INDESIT company

Model type:
TCDG51XBKEU

Commercial code:
F067779

07337-20 Exploded views

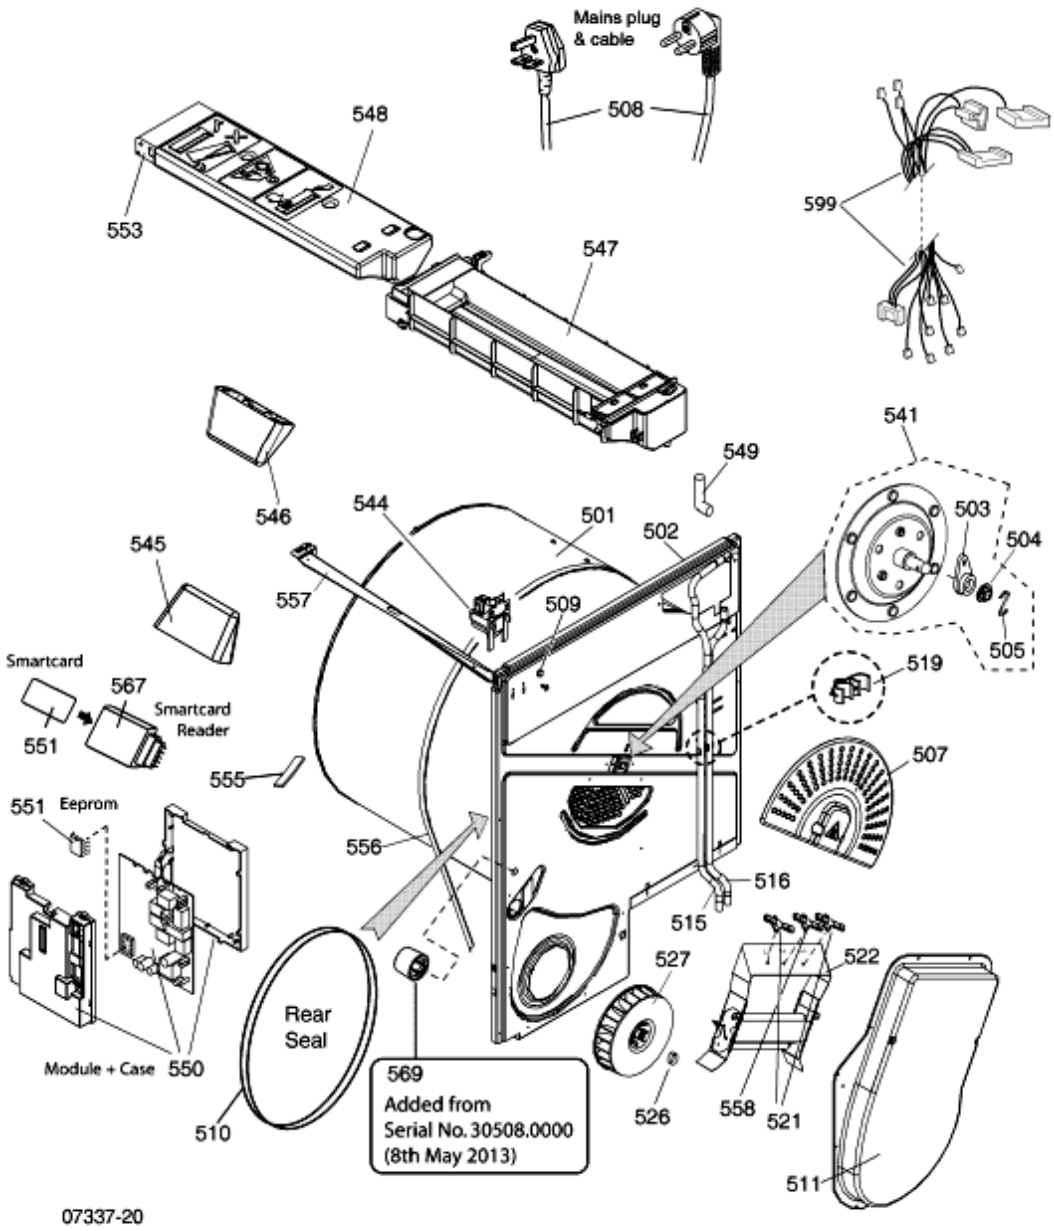
n4410f01: 350 MOTOR AND B Energy BOM Changes

From 16/08/2010, Serial No.0816.0001 the build of some 7.Kg, 7.5Kg & 8Kg level 2 and level 3 B Energy rated condenser dryers changed to a new B Energy build using an A2 control module with 4.5.14 firmware along with a new type 362 motor and 2.3Kw insulated heater assembly. The base unit is based on the Aqualtis B Energy but using the C Energy type condenser unit with the base duct and motor covers removed.

n4411j00: PATTERN DRUM INTRODUCED

FROM OCTOBER 2011 A PATTERN DRUM HAS BEEN USED IN PRODUCTION.
THE PATTERN DRUM IS INTERCHANGABLE WITH THE PREVIOUS PLAIN DRUM.
ONCE STOCKS OF THE PLAIN DRUM ARE EXHAUSTED.
THE PATTERN DRUM WILL BE THE SERVICE SPARE.

NOTE
TWO PLAIN DRUMS WERE USED IN PRODUCTION.
THE DRUM SHAFT CAN ONLY BE REPLACED IF THE ORIGINAL DRUM TO SHAFT FIXING IS SCREWED. IF THE DRUM SHAFT IS RIVETED TO THE DRUM, THE COMPLETE DRUM HAS TO BE REPLACED.

n4414a03: BEARING PADS REDUCED

FROM JUNE 2013 THE NUMBER OF BEARING PADS FITTED IN PRODUCTION WAS REDUCED FROM 5 to 4.
FROM THIS DATE THE LEFT HAND BEARING PAD (WHEN VIEWED FROM THE FRONT) IS NO LONGER FITTED

12721-15 Exploded views

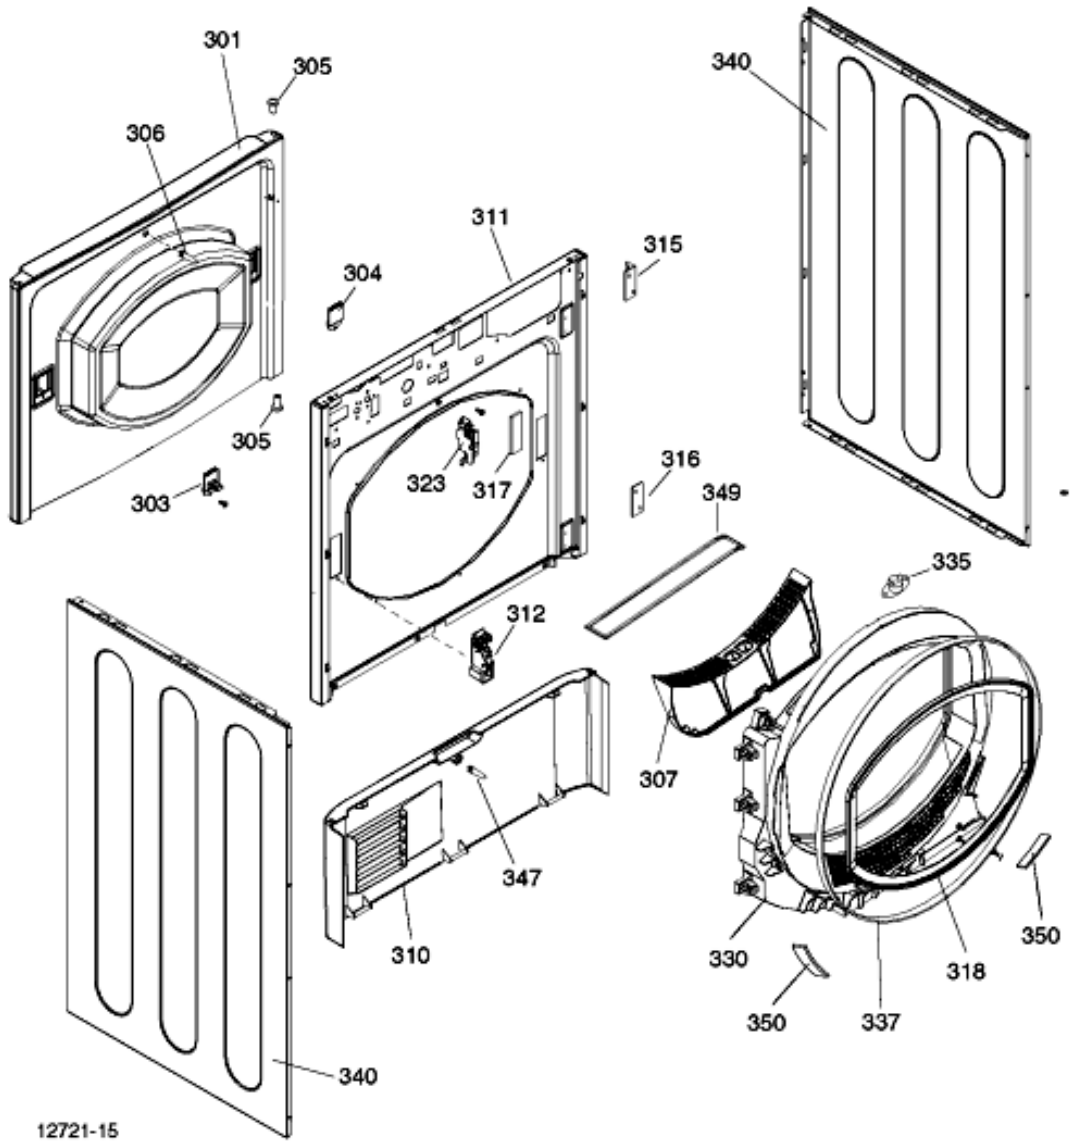
n4411g07: CONDENSER FRONT AIR DUCT COLOUR CHANGE

FROM JUNE 2011 THE FRONT AIR DUCT FITTED TO CONDENSER TUMBLE DRYERS CHANGED IN PRODUCTION FROM GREY TO WHITE.
SELECTED THE CORRECT PART BY DESCRIPTION IN THE PARTS LIST
